**BELL BEND NUCLEAR POWER PLANT  
DATA TO SUPPORT THE  
NBSR CLOMR REQUEST  
BNP-2012-079                      Docket No. 52-039**

- Reference: 1) Case No.: 11-03-1701R  
Susquehanna River  
Communities: Township of Salem, and Township of Conyngham, PA  
Community Nos.: 420625 and 420600
- 2) FEMA-2012-047, B. Kaiser, FEMA, to B. Ehrhart, LSI, "Summary of Additional Data Required to Support a Conditional Letter of Map Revision, Case No.: 11-03-1701R", dated February 6, 2012.

# Bell Bend Nuclear Power Plant Flood Study Report Susquehanna River

Rev.5, April 11, 2012

**Appendix C:**  
**Annotated FIRM**

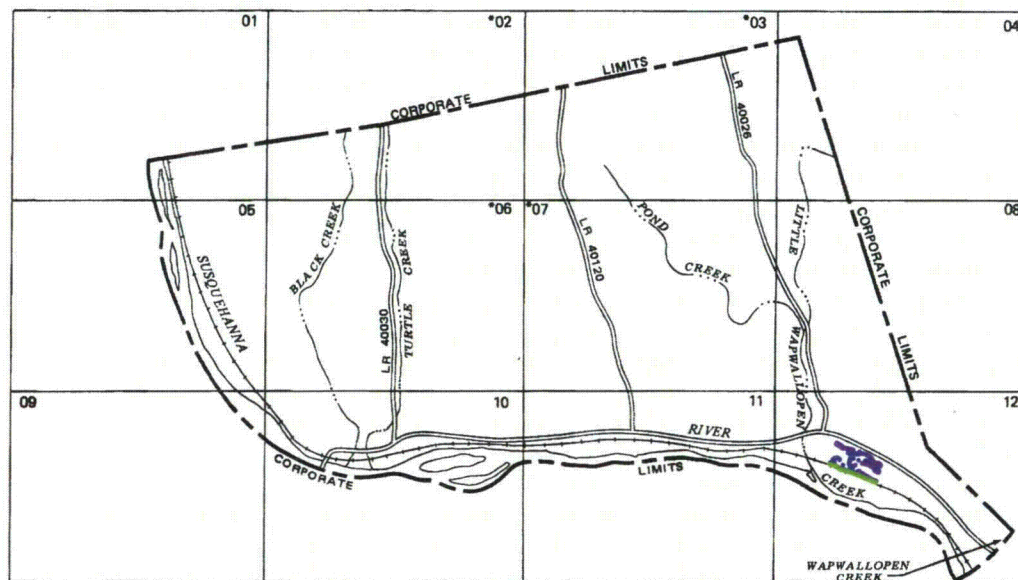
- 3. Based on the revised work map, please submit a revised annotated Flood Insurance Rate Map (FIRM) Panel panels for 4206250020B, 4206000005B, 4206000010B, 4206000011B, and 4206000012B and Flood Boundary and Floodway Map (FBFM) panels 4206250020, 4206000005, 4206000010, 4206000011, and 4206000012, at the scale of the effective FIRM and FBFM, that shows the revised boundary delineations of the base floodplain, 0.2 percent-annual-chance floodplain, and regulatory floodway shown on the submitted work map, and how they tie-in to the boundary delineations shown on the effective FIRM at the downstream and upstream ends of the revised reach.*

Appropriate revisions have been made to the Salem Township FIRM and FBFM Panels (4206250020B) based on the flood model revisions. Because only the Map Index is available for Conyngham Township, the Map Index has been annotated. Note that the proposed changes only affect panel 426000012.
